**ABU GHRAIB DAIRY
ABU GHRAIB, IRAQ**

**SIGIR PA-09-172
JANUARY 14, 2009**

Abu Ghraib Dairy

Summary of Report: PA-09-172

Figure 2. Primary truss configuration

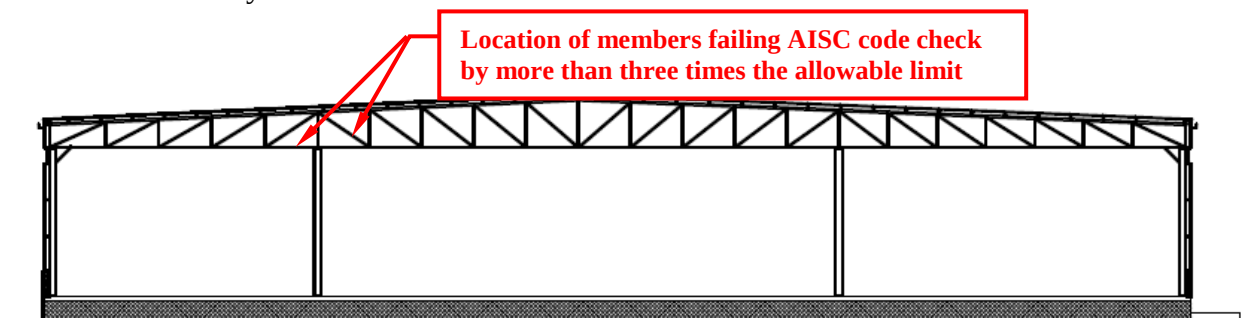
- Based on the contractor's calculations, five members of the truss were designated as failing the AISC code check. Two of the members failed the code check by more than three times the allowable limit (Figure 2). Failing by a factor of this magnitude indicates that the members could yield and possibly fracture under the design load.

The contractor's proposed structural design consists of steel columns and continuous truss construction with sandwich panel cladding¹⁸ for the roof and sidewalls. Roof loads are carried by the multi-span steel trusses, which have two configurations. The primary configuration has steel columns supporting the truss at the ends and at approximately one-third span (Figure 2). The columns are centered on a truss panel point (the location of intersecting truss members), which is appropriate. Based upon the contractor's drawings, it appears that the member sizes have been modified to accommodate the stress reversal¹⁹ over only one of the interior columns.

Figure 3. Truss configuration at mezzanine level

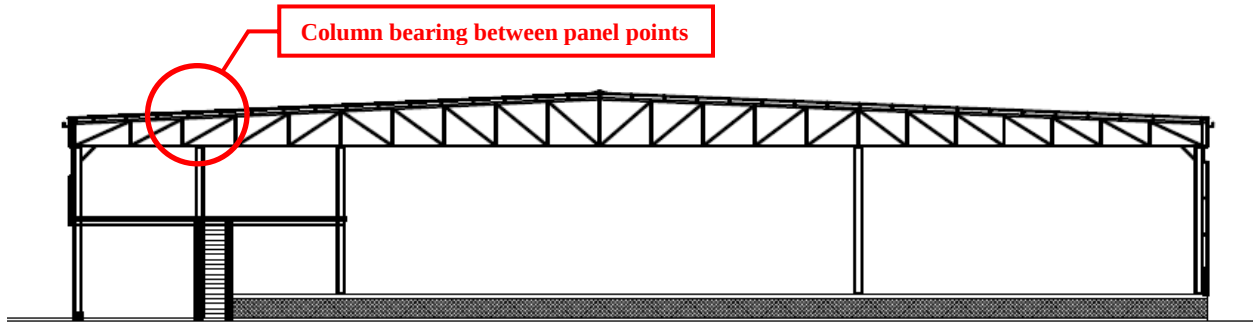
In the area of the mezzanine, the plans show additional columns (Figure 3), which extend through the mezzanine to the underside of the truss. The additional bearing locations provided by these columns are not at a truss panel point. The resulting reactions from these columns will introduce bending into the lower chord of the truss. SIGIR is

concerned that the members used in the lower chord of the truss are relatively light and do not appear to have the capacity to resist a significant amount of bending stress in addition to the compressive load that will result from the intermediate support.

Figure 4. Knee brace detail

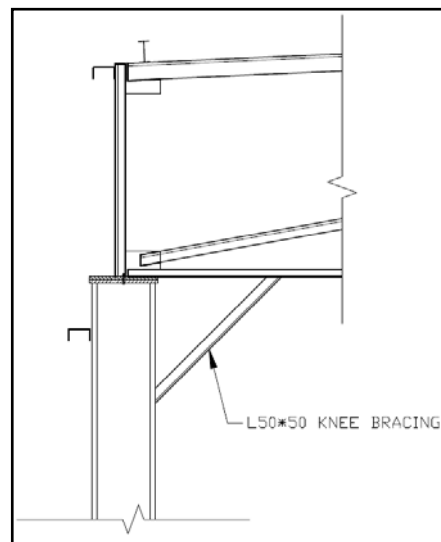
The contractor's design drawings do not address the method used to resist lateral loads parallel to the building's gable. It appears that the design incorporates diagonal cross bracing between several bays in the direction parallel to the ridge; however, there is no indication of bracing parallel to the gable (slope). In addition, the building's use of column and truss construction requires additional consideration of lateral loads. The only members that appear to be placed to provide lateral stability in the axis of the gable are the diagonal knee braces (Figure 4). These knees appear to be severely undersized, considering their location and configuration.

If the braces are used to resist lateral loads, the connection between the columns and truss would become, at least, partially fixed. This would introduce significant load into the lower chord of the truss, which appears to be already undersized. Fixing the truss/column connection would also introduce a lateral component into the column reaction; special consideration would then be required in the design of the foundation to resist this load.

Site Photo 1. Typical foundation pedestal and anchor bolts

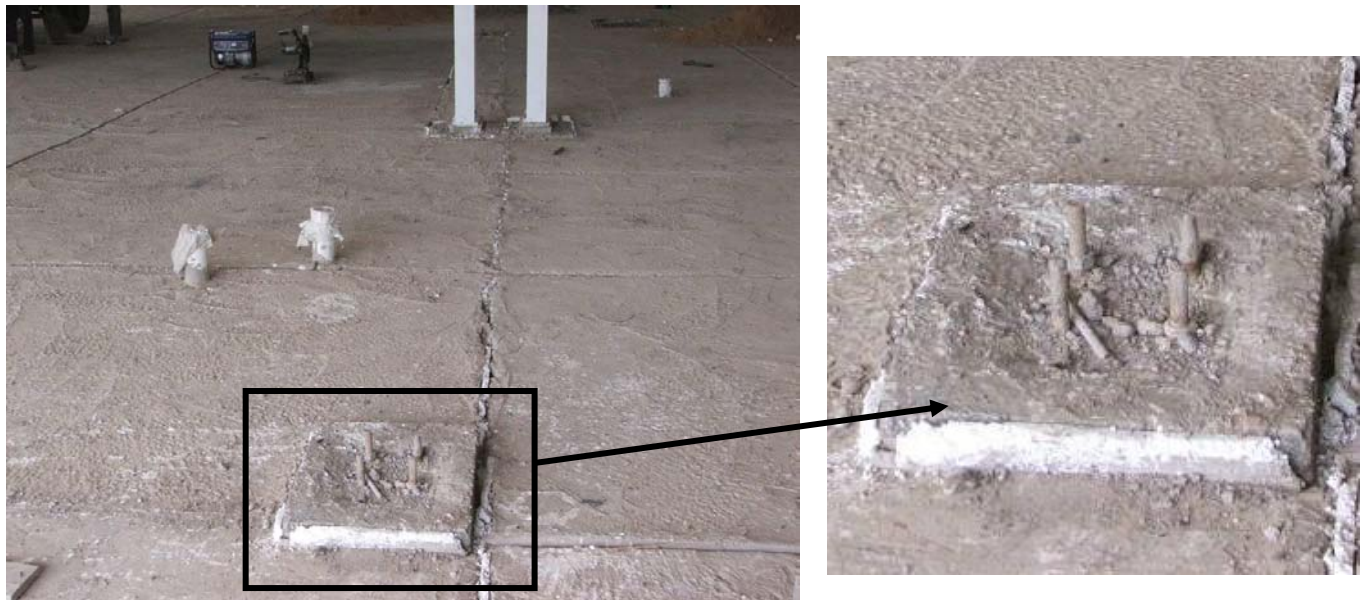
At the time of the site visit, the foundations for the facility were installed. The foundation system appeared to be concrete pedestals with steel anchor bolts attached to the base plates of the steel columns (Site Photo 1). The foundation system also included spread footings to support the concrete pedestals and columns. Since the foundation was in the later stages of construction, only the upper portion of the foundation was exposed for inspection; consequently, SIGIR could not verify the construction of the foundation.

Site Photo 4. Cross brace conflict with CMU perimeter wall

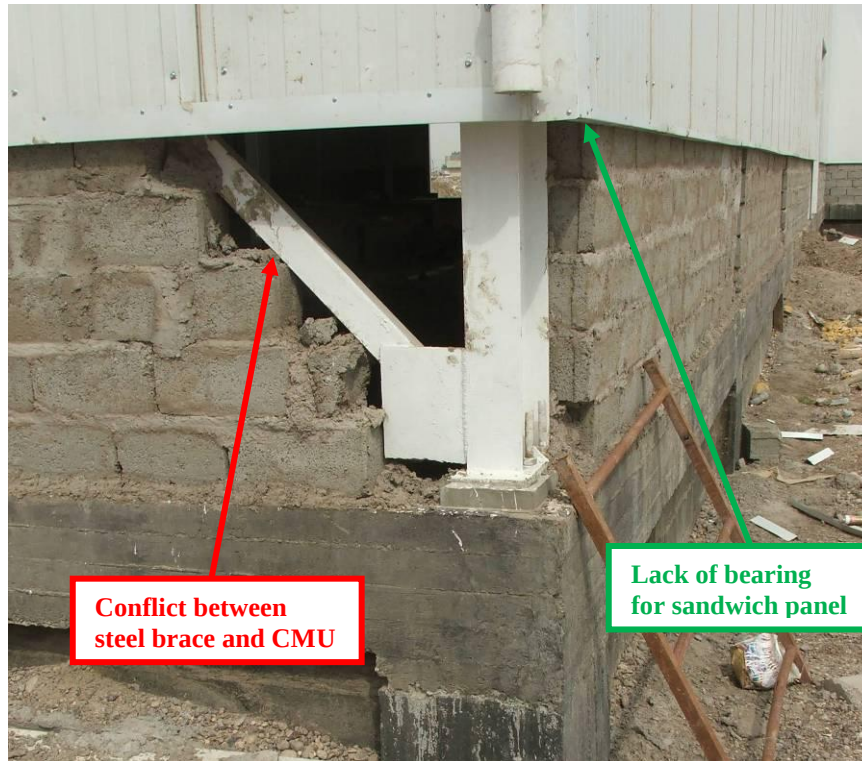
The CMU wall interferes with the steel cross bracing between several of the columns (Site Photo 4). It appears as if the contractor's solution to this issue was to lay the CMU wall around the bracing and coat the entire area with plaster. However, this approach may cause future problems as the steel bracing moves independently of the CMU wall causing recurrent cracking at the location.

Previously, SIGIR noted that due to the contractor's deviation from the design drawings, the steel cross bracing for the structure conflicted with the CMU perimeter wall. To correct this, the contractor removed the CMU wall, relocated the steel cross bracing to the interior of the wall, and reconstructed the wall (Site Photos 19 and 20).

Site Photo 5. Course of CMUs placed with cores horizontal

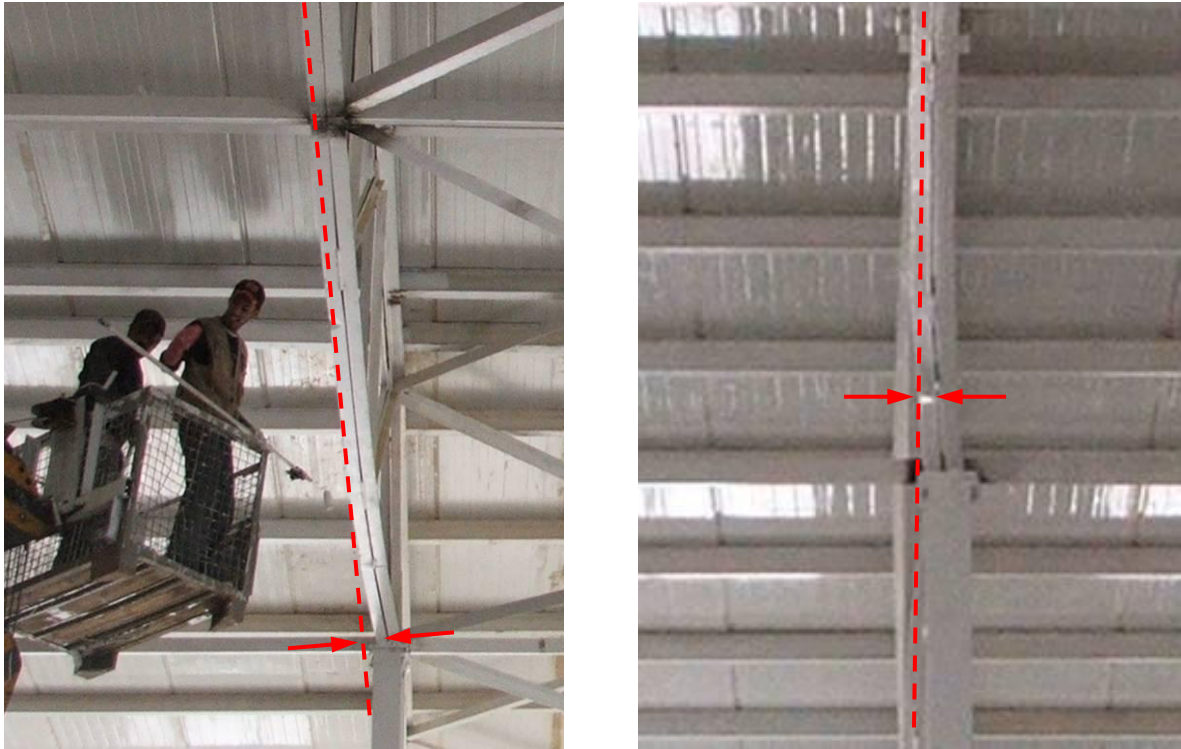
SIGIR also noticed several areas where one course of CMUs was laid on their sides (cores horizontal) (Site Photo 5). The detailed plans did not show this type of construction technique and it is unclear why the contractor did this. SIGIR's concern is that CMUs are significantly weaker when placed in this orientation. If these CMUs are intended to support the weight of the loaded floor slab, additional reinforcement of this area is needed.

The quality of the construction of the floor slab was very poor and appeared to have been poured without the correct tools or equipment. The slab has high and low spots in various places and raised tool marks from what appears to be preliminary leveling of the

slab. There is no indication that final finishing was performed after preliminary leveling. The slab's inconsistency may create problems for forklift traffic and future equipment installation.

Site Photo 18. Contractor's truss modification

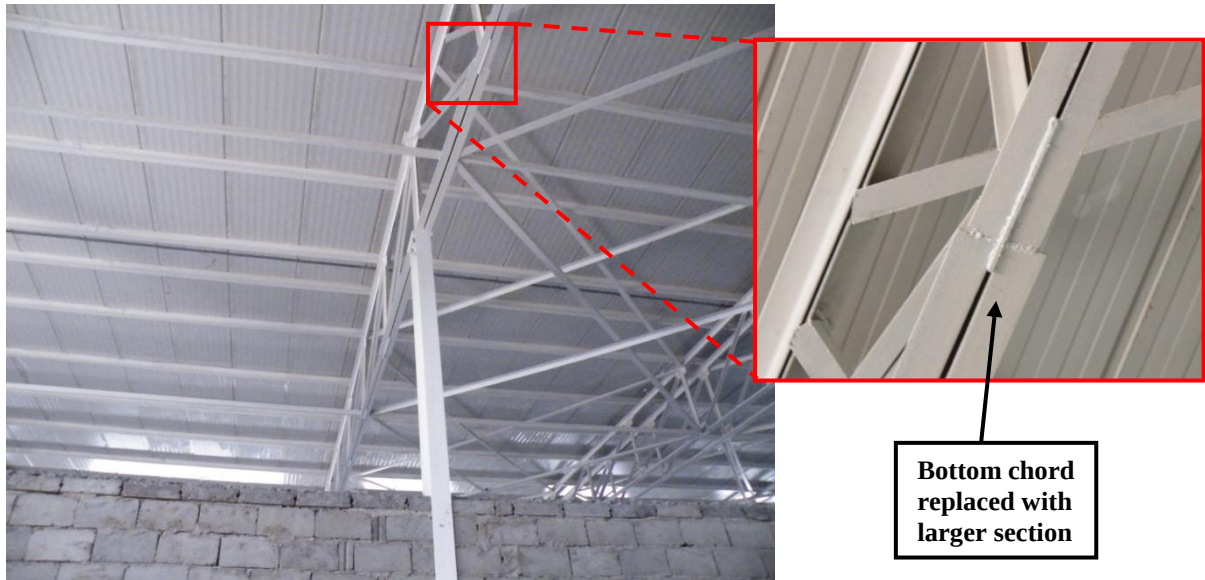
In order to remedy the deformation of the roof trusses SIGIR previously identified, the contractor's modification included the removal of the lower truss chord in the area where

it was inadequate and replaced it with a larger section. Aerial lift capabilities were not available at the time of the site visit; therefore, a hands-on inspection of the repair could not be made. However, SIGIR was able to verify that the trusses had a larger bottom chord section in the areas previously noted as deficient (Site Photo 18).
